MEMORANDUM

TO: CR 466A Landfill Facility, LLC's permit file 1190036-004-AO

<b>Air Permitting Supervisor - Required Information for Project Setup by Admin</b>			
Owner/(Facility Name, if needed):	C.R. 466-A Landfill Facility		
Facility ID No.:	1190036		
Project Name:	Operation Permit Renewal		
Project Description:	Operation Permit Renewal		
Facility Type:	<input type="checkbox"/> New <input type="checkbox"/> Relocatable	Total Fee Submitted (\$):	1000
Type/Subtype:	AO2B	Total Fee Required (\$):	1000
Date Received:	10/22/07	Net Fee Needed (\$):	0
Fee Status:	<input checked="" type="checkbox"/> Correct <input type="checkbox"/> Incorrect <input type="checkbox"/> NA	Net Fee Refund (\$):	0
Fee Checked By:	cz	Fee override reason: (if needed)	none
Date Fee Checked:	10/23/07

SIDE  
VIEW

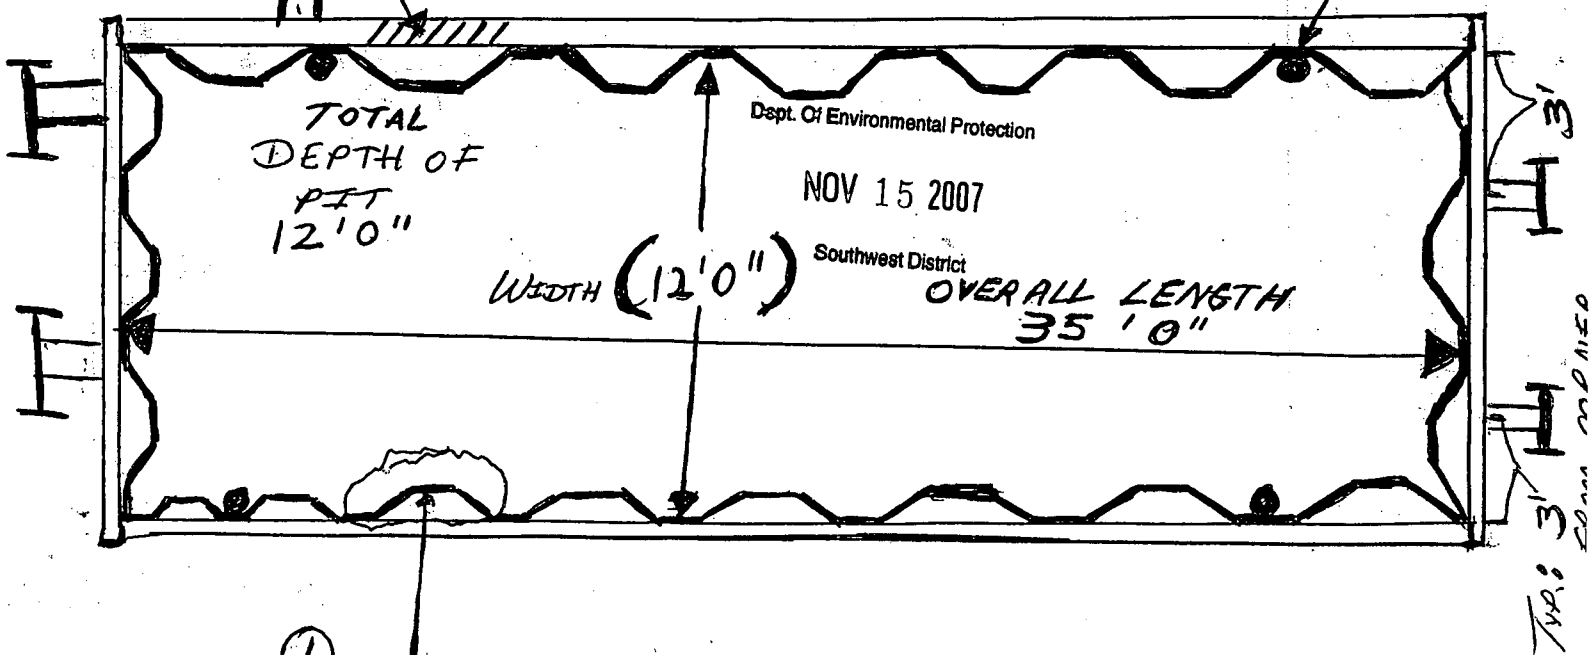
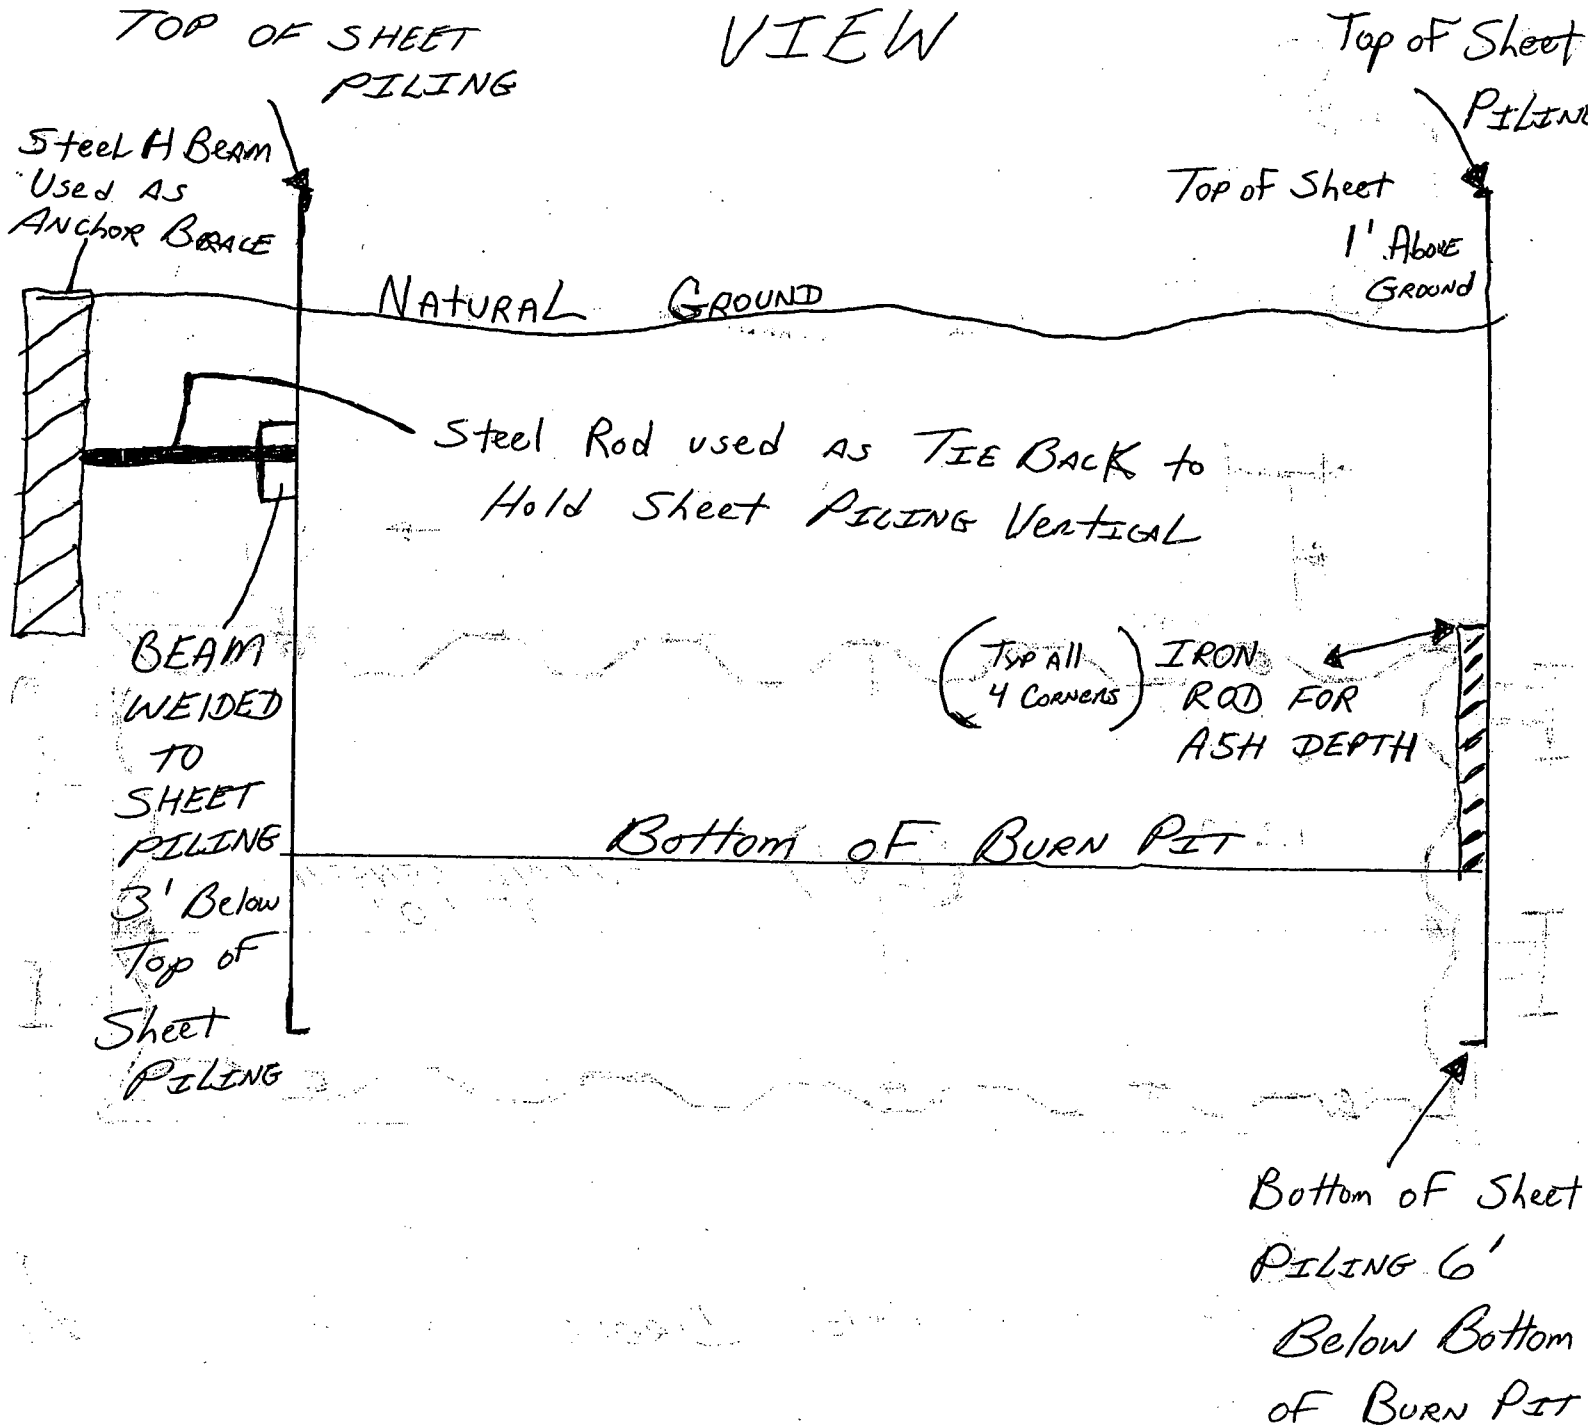
- C. *The pit's four (4) walls were not in a vertical position, which does not provide reasonable assurance a proper air curtain can be maintained.*

- D. *The pit's length (approx. 42 feet) was more than the length of the manifold (approx. 32.5 feet), which does not provide reasonable assurance a proper air curtain can be maintained. See Specific Condition No. 10 of Permit 1190036-002-AO.*

- H. *The pit did not have an indicator to show the pit's 1/3 depth. See Specific Condition No. 21 of Permit 1190036-002-AO.*

**Response:** The ACI pit is proposed to be re-constructed to achieve the required measurements as shown on the attached sketch by using steel sheet piling and "H-Beam" anchoring. This configuration will provide a solution to maintaining the required ACI pit dimensions.

**Response:** There was a steel pipe inside the pit bottom indicating the 1/3 depth as required. Due to the heat of the ACI pit during the inspections, the pipe could not be observed by the inspectors. Please see the attached ACI pit sketch which shows solid iron rods for the four (4) corners of the pit to be set at 1/3 the depth of the pit.
